**RE: NOTICE OF DISAPPROVAL
WORK PLAN FOR GROUNDWATER MONITORING
BULK FUELS FACILITY SOLID WASTE MANAGEMENT UNITS ST-106 AND SS-111
KIRTLAND AIR FORCE BASE, NEW MEXICO
EPA ID# NM6213820974
HWB-KAFB-21-003**

The New Mexico Environment Department (NMED) is in receipt of the Kirtland Air Force Base (Permittee) *Work Plan for Groundwater Monitoring* (Work Plan), dated April 2021. NMED has reviewed the Work Plan and hereby issues this Disapproval with the following comments.

Figure 1: 2016/2017 EDB Active vs Passive linear regression for all data pairs within the relative range of the Screening Level, or with a value greater than the detection limit and less than 0.1 µg/L, or double the SL.

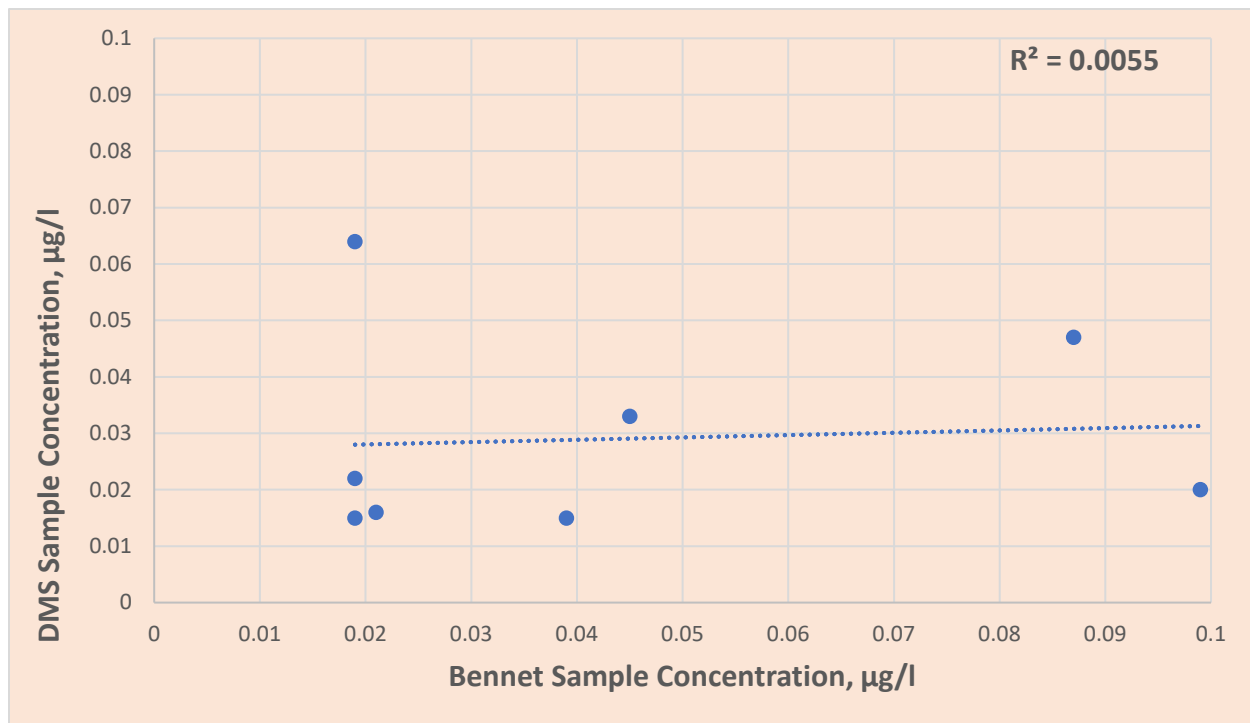
To illustrate the point further, the critical range for accuracy and precision in data collected for compliance determination is near the screening level for the particular pollutant. For EDB, the groundwater screening level is 0.05 µg/L. Figure 1 is a linear regression graph of all EDB data pairs that are greater than the detection limit and less than 0.1 µg/L. A trendline was added in order to determine the correlation coefficient, or R^2 value. Industry standard for establishing correlation is an R^2 value of 0.9 or greater. The R^2 value for KAFB's comparative study EDB concentration data in close range to the screening level is 0.0055. This illustrates that there is very little correlation at all in this critical concentration range.

The information above clearly demonstrates that the passive sampling method employed by KAFB is neither accurate nor precise; the method does not produce representative samples. Over 60% of the EDB sample method pairs and over 70% of the benzene sample method pairs with a value above the detection limit failed the KAFB %RPD criterium of 35%.

1. KAFB must eliminate all passive sampling at the BFF and replace it with active sampling methods that can provide representative data. The replacement needs to be implemented as soon as possible after approval of the work plan to replace passive

Figure 2: 2016/2017 EDB Active vs Passive linear regression for all data pairs with a value above the detection limit

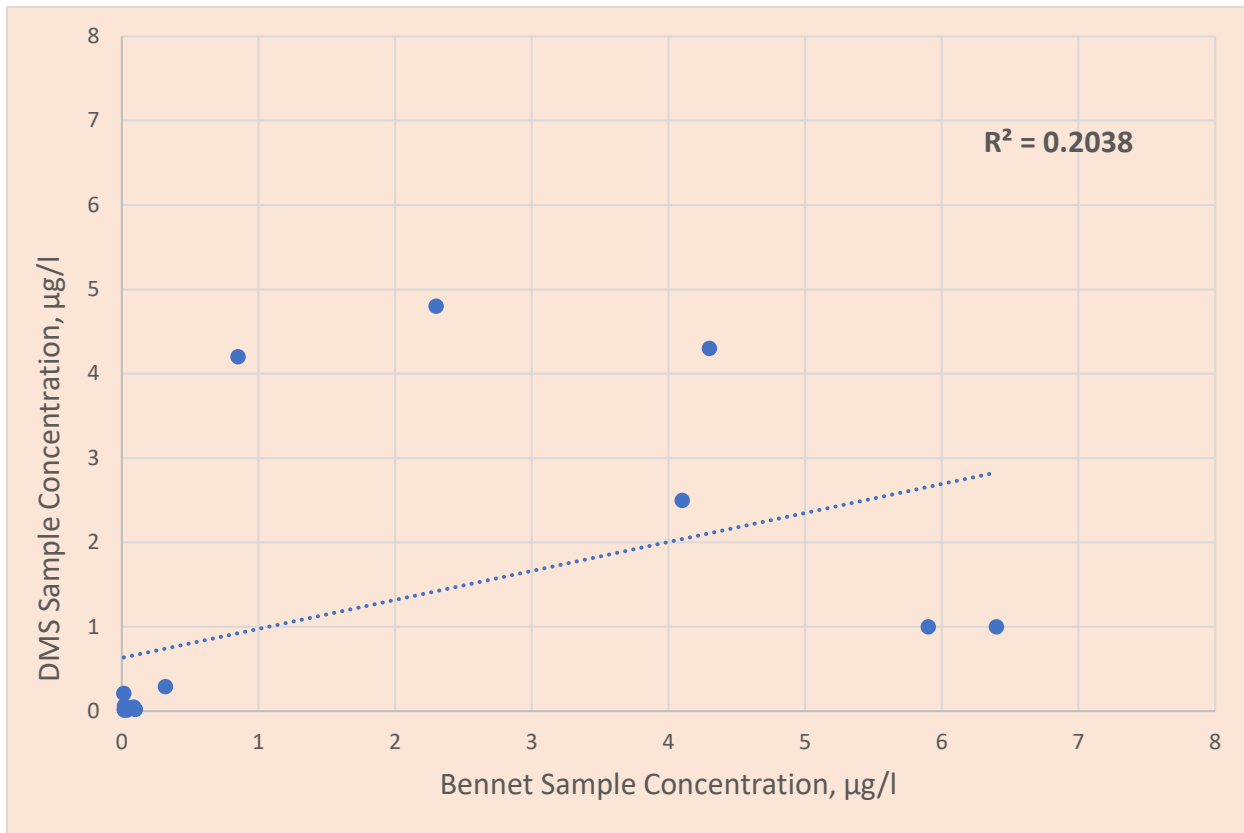
Figure 2 provides the same linear regression graph for all EDB data pairs that are greater than the detection limit. For this dataset, the R^2 value was 0.2, again indicating very little correlation between the data pairs.

Some paired data points for EDB are over an order of magnitude apart. The passive sampling data is not reliable and, had it been relied upon, would have resulted in three of the 22 samples being mischaracterized regarding compliance with the screening level. Based on this evaluation and the clear indication that the passive sampling method is not providing accurate, precise, or representative data, all passively sampled data collected at KAFB is suspect, considered qualitative, and cannot be used for site evaluation or decision-making purposes.
